CALL NO. 309  
CONTRACT ID NO. 111343  
ADDENDUM # 1

Subject: Hardin County, JP02 047 NEW-ROUTE  
Letting October 21, 2011

- (1) Revised - Plan Sheets - R2K, R114, R116, R117, R120 & R121
- (2) Revised - Bid Items - Pages 106-113 of 113

GENERAL SUMMARY

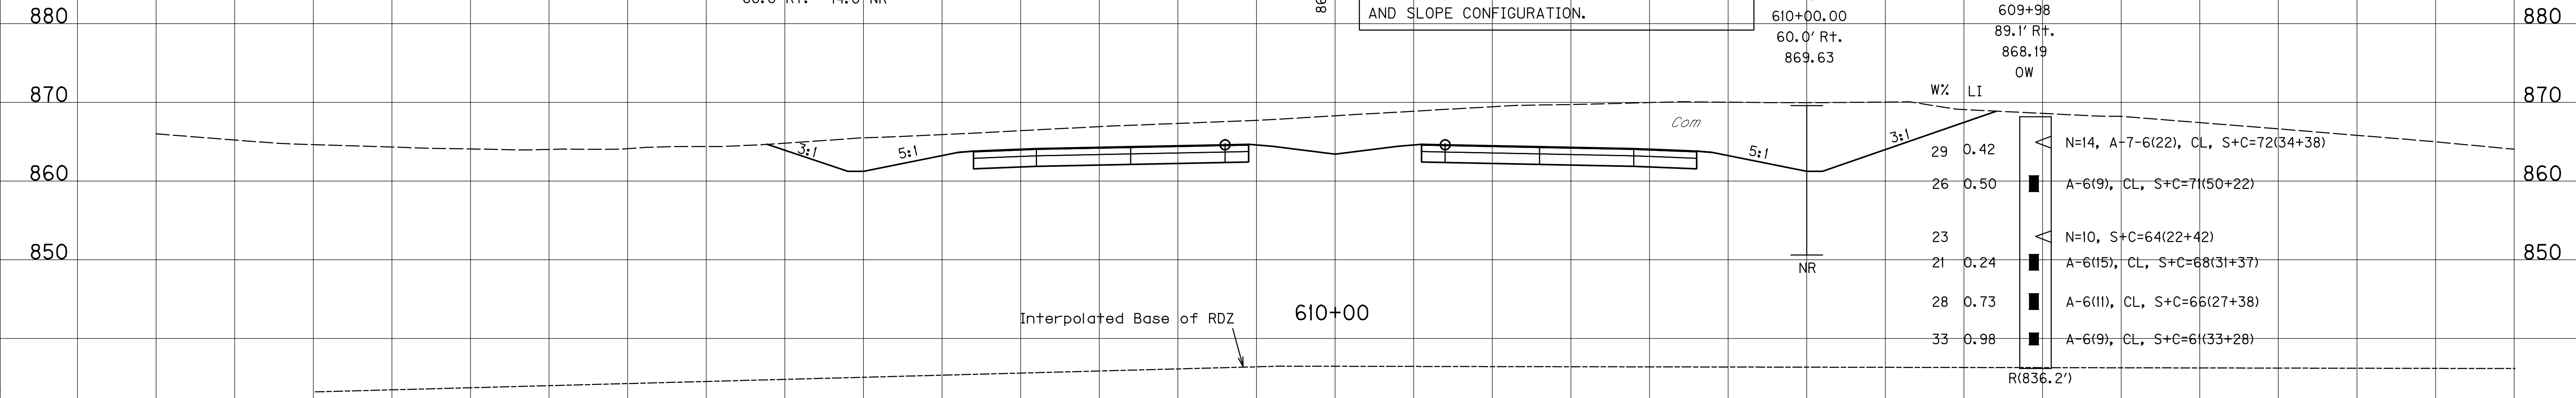
**REMOVED BID ITEM 2714 (SHOULDERING)**
